# Staff Report

Re: PLNPCM2020-00258

## Kozo House Apartments - Design Review

**REQUEST:** David Clayton, applicant, is requesting Design Review approval for a proposed 312-unit mixed use building located at approximately 175 North 600 West in the TSA-UC-T Transit Station Area zoning district. The Applicant has included a request to exceed the maximum length of a street-facing façade and to modify the spacing of building entrances along 200 North and 600 West and the maximum length of a blank wall.

North Elevation  
NOT TO SCALE

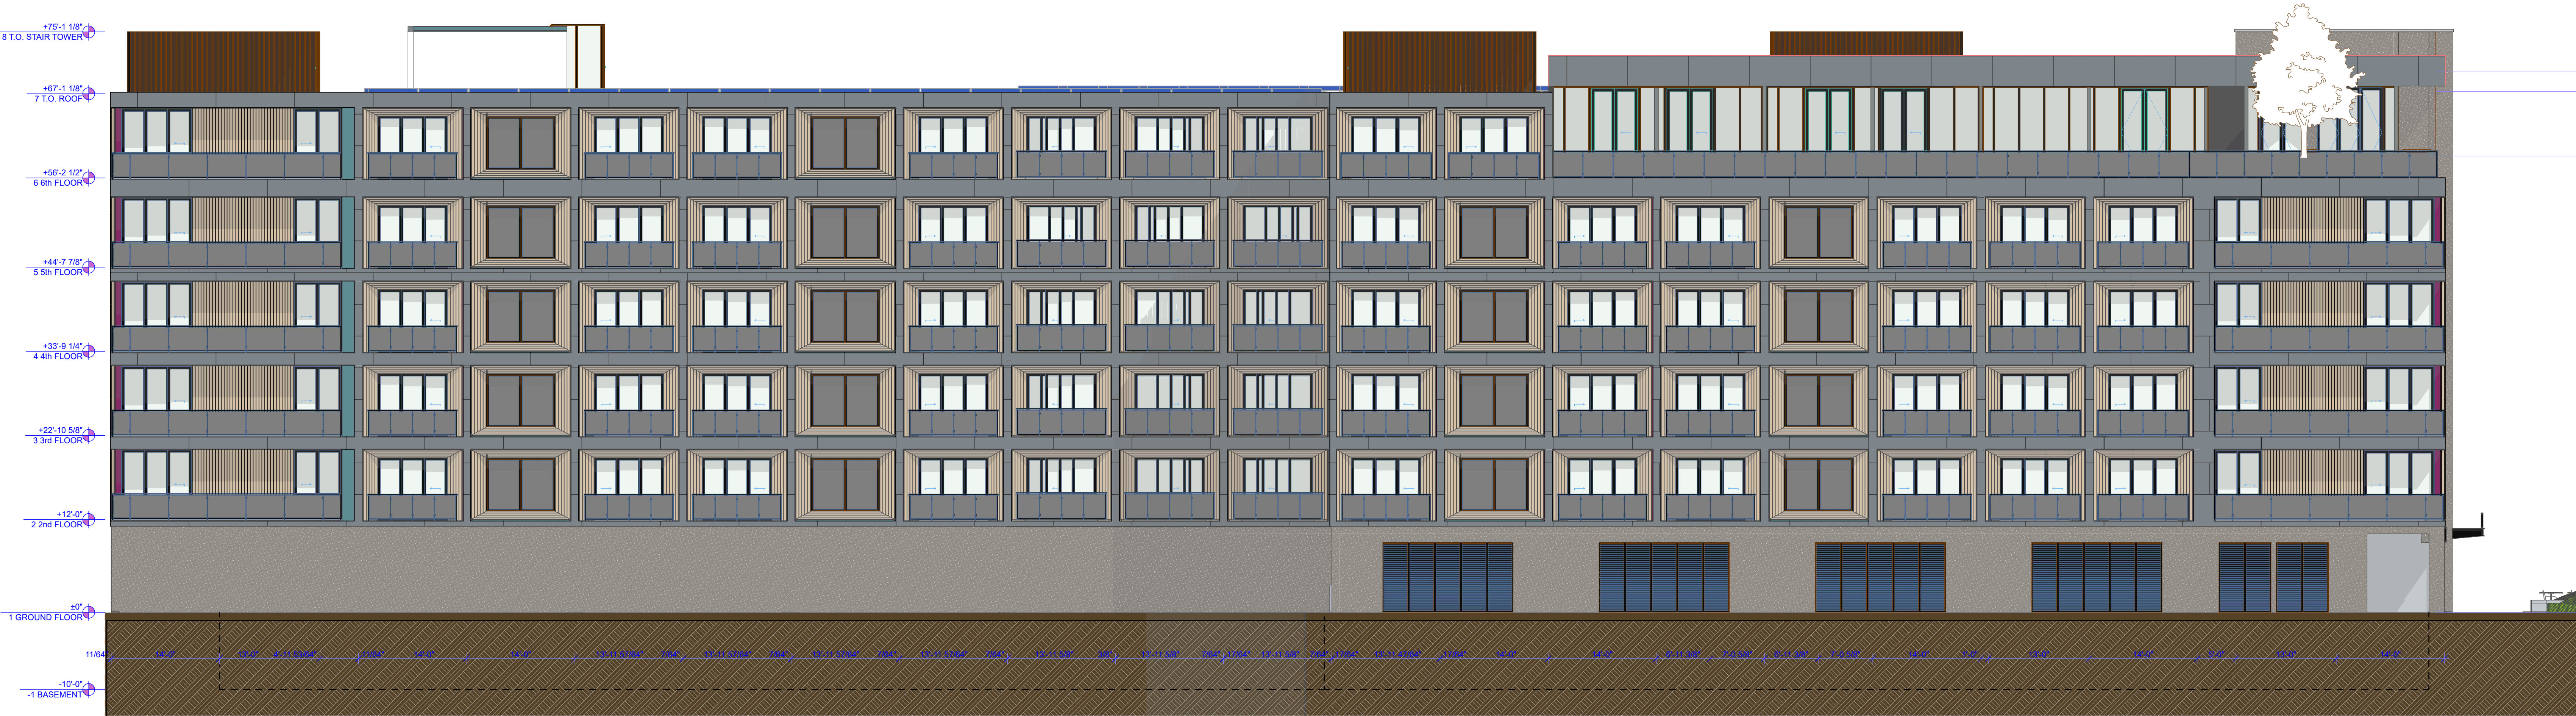
The maximum length of a street-facing façade is two hundred feet (200'). The Applicant has modulated the building by including a thirty foot (30') wide amphitheater style stairway into an internal courtyard. The Applicant has proposed the inclusion of landscaping throughout this stairwell as well to further separate the principal building into two apparent halves.

The maximum allowed distance between building entrances is forty feet (40'). The northern façade of the Kozo House Apartments is approximately 300' long. The applicant has proposed seven doors along this frontage, which averages out to one door every 42.857 feet. The eastern façade of the Kozo House Apartments is approximately 175' long and the applicant has proposed four doors along this building face, which averages out to one door every 43.75 feet.

The maximum length of a blank wall along a street facing façade in the TSA-UC-T zone is fifteen feet (15'). The Kozo House Apartments project includes a blank wall along the northern façade (facing 200 North) approximately thirty feet (30') in length. This section of wall is located immediately to the west of the proposed amphitheater steps into the interior courtyard. Behind this wall are three parking stalls within the internal parking garage. This wall is proposed to be sheathed in concrete and will block light and noise pollution from the parking garage for the surrounding neighbors.
